MEMORANDUM

TO: Historic Preservation Board
 FROM: Merrillyn C. Rathbun, Fort Lauderdale Historical Society
 SUBJECT: Agenda for December 5, 2016
 DATE: November 29, 2016

Case	H16015	FMSF#	
Review and Comment	Henry F. Kinney Tunnel/Tunnel Pedestrian Plaza		
Owner	FDOT/City of Fort Lauderdale		
Developer	City of Fort Lauderdale/Elizabeth Van Zandt		
Address	SE 6th Avenue/Las Olas Blvd. Tunnel		
General Location	Intersection of East Las Olas Boulevard and South Federal Highway		
Legal Description	<p>A PORTION OF RIGHT OF WAY AT THE INTERSECTION OF EAST LAS OLAS BOULEVARD AND SOUTH FEDERAL HIGHWAY IN SECTION 11, TOWNSHIP 50 SOUTH, RANGE 42 EAST MORE PARTICULARLY DESCRIBED AS FOLLOWS:</p> <p>BEGIN AT THE NORTHEAST CORNER OF TRACT 2, "BURNHAM'S SUBDIVISION", ACCORDING TO THE PLAT THEREOF, RECORDED IN PLAT BOOK 15, PAGE 29, OF THE PUBLIC RECORDS OF BROWARD COUNTY, FLORIDA; THENCE SOUTH 87°34'20" WEST ALONG THE NORTH LINE OF SAID TRACT 2 AND ALSO BEING THE SOUTH RIGHT OF WAY LINE OF EAST LAS OLAS BOULEVARD, A DISTANCE OF 23.00 FEET; THENCE NORTH 02°33'11" WEST, A DISTANCE OF 80.00 FEET; THENCE NORTH 88°05'12" EAST, A DISTANCE OF 36.70 FEET; THENCE NORTH 01°54'48" WEST, A DISTANCE OF 75.0

Fig. 1 Tunnel slip road, U.S. 1, looking north

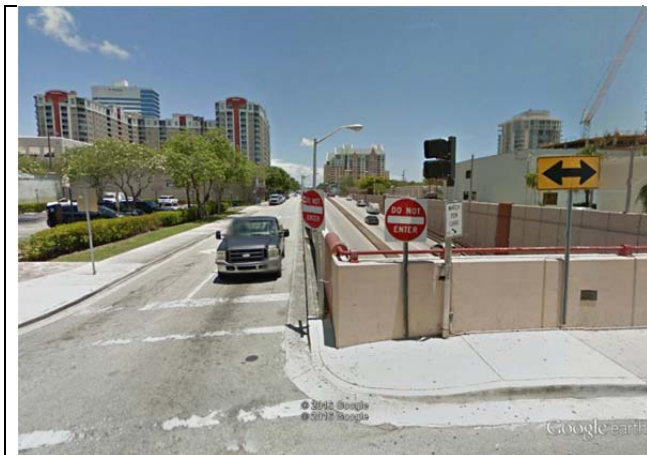
Description of the Project: The applicant has brought a project to the Board to build a pedestrian plaza on top of the NR¹ eligible Henry F. Kinney tunnel. The project would involve structural changes to the tunnel. Presently, according to the applicant's report, an auto driver's sight, approaching the intersection at Las Olas Boulevard, is blocked by the height of the tunnel wall from seeing an approaching pedestrian trying to cross at the slip road.

Figure 1. Showing National Register listed properties, no. 1 Bryan Building and no. 2 New River Inn; Proposed development and H-1 Historic District (small buildings left side of picture) showing contributing properties and The Shippey House and the Replica Schoolhouse.

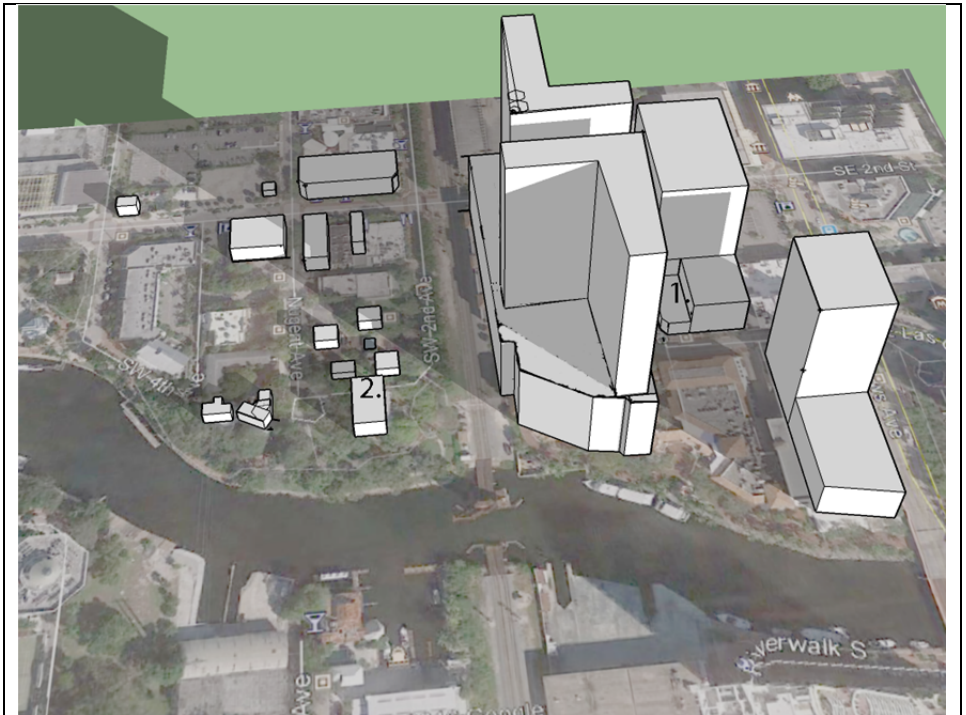
The proposed project is across Brickell Avenue from the NR listed Bryan Building (Fig. 1, no. 1) and is adjacent to the locally designated H-1 Historic District.

New construction in the H-1 District is limited to 25 feet in height; the tallest building in the district is probably the NR listed New River Inn at approximately 36 feet. The massive 41 story Riverfront project will create an immense wall effect effectively isolating the historic district from the downtown. A person standing on the front porch of the contributing Philemon Bryan Home would not be able to see the top of this project.

Figure 3. Shadow effect on NR Listed Bryan Building

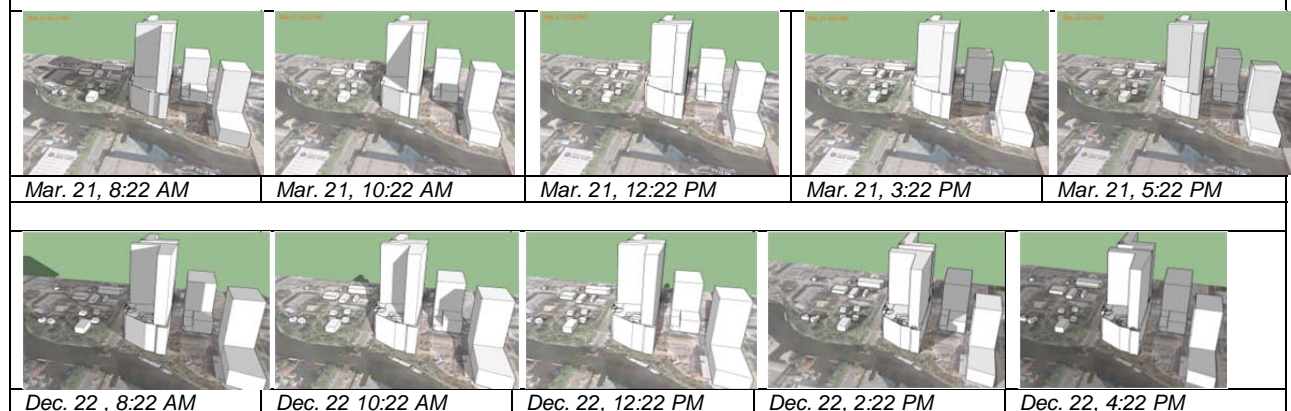
The Bryan Building on Brickell Avenue would have a serious shadow impact at various times of the year (see Fig. 3). The adjacent sixteen-story bank building would be affected; its façade, the western elevation, could be completely in shadow at times.
